ADDENDUM #1

Reference: Tooele Maintenance Facility Replacement
Utah Department of Transportation – Tooele, Utah
DFCM Project No. 06033900

ADDENDUM NO. 1 to the Contract Documents for the Construction of UDOT Maintenance Station #2423, Tooele, Utah.

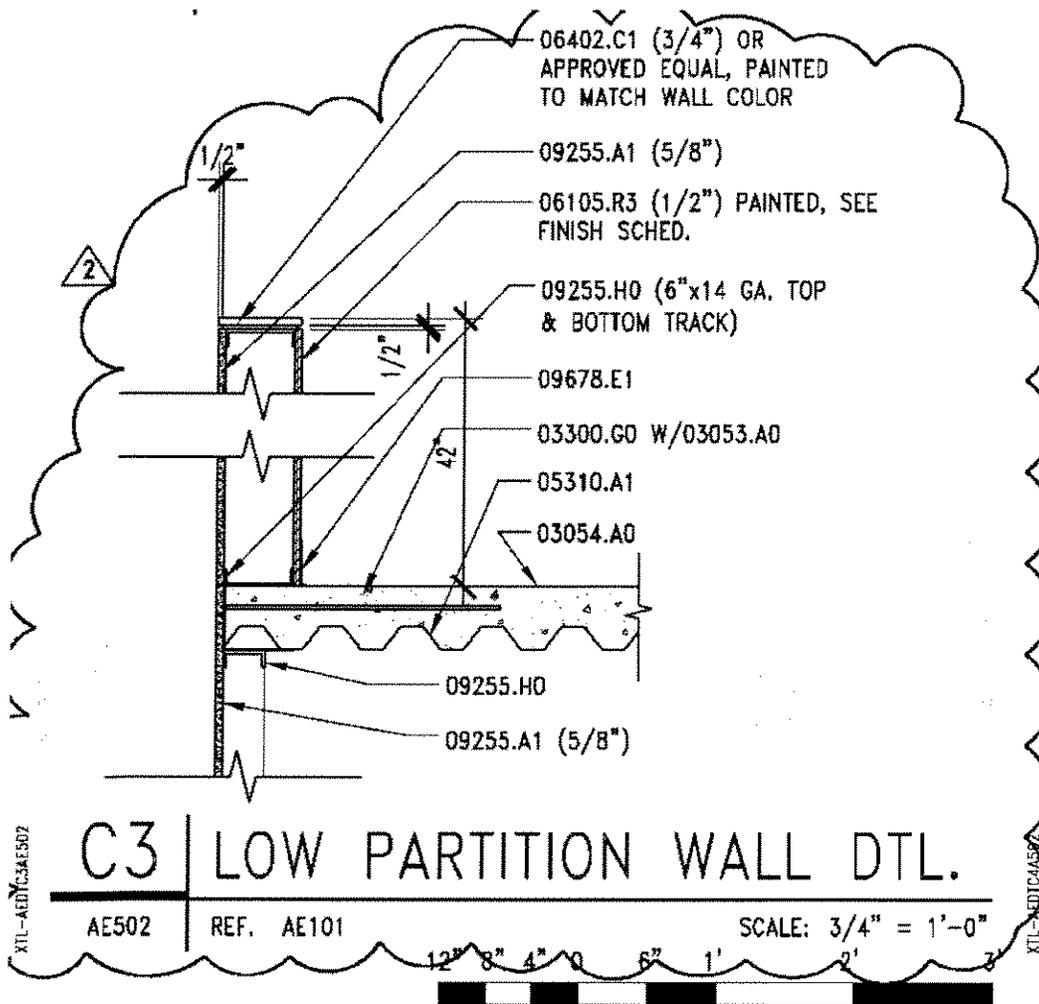
- a. Delete Specification #03055 in its entirety.
- b. **Sheet G000** – Add note “CONSTRUCTION OF NEW STATE BUILDINGS AND REMODELING OF EXISTING BUILDINGS SHALL COMPLY WITH ALL THE REQUIREMENTS OF THE DFCM STANDARDS, INCLUDING ENHANCED ACCESSIBILITY. THE DFCM STANDARDS CAN BE FOUND AT THE FOLLOWING WEB SITE: www.dfcu.utah.gov.
- c. **Sheet AE401** – Revise Detail B2/AE401 to included notes.
See attached sheet 1.1.
- d. **Sheet AE501** – Add General Note #4: CONTRACTOR TO ENSURE THAT THE METAL BUILDING MANUFACTURER PROVIDES STRUCTURAL GIRTS IN SUFFICIENT QUANTITY TO SUPPORT INTERIOR FINISHES.
- e. **Sheet AE502** – Revise Detail C3/AE502 to included rubber base @ mezzanine.
See Attached sheet 1.2.
